## CONNECTING ROD BEARING INSERTS

### The Type

Fig. 2

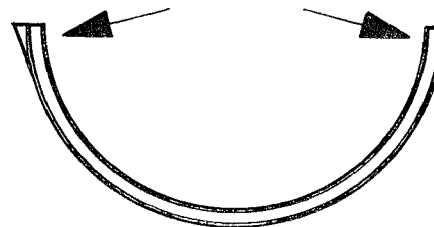
1600 engines - beginning with engine No. P-606 801  
1600 S engines - beginning with engine No. P-700 001  
1600 S-90 engines - beginning with engine No. P-804 001

will be equipped with modified connecting rod bearing inserts. The spare part number for this new type has not been changed. The modified connecting rod bearing inserts are not readily reconizable.

The main feature of this modification is that the bearing inserts are by 0.02 to 0.035 mm thinner for a length of 7 mm, starting from the mating surfaces of both bearing inserts (see Fig. 2).

It is important to make sure that only the modified bearing inserts are used for the Type 1600 S-90 engines.
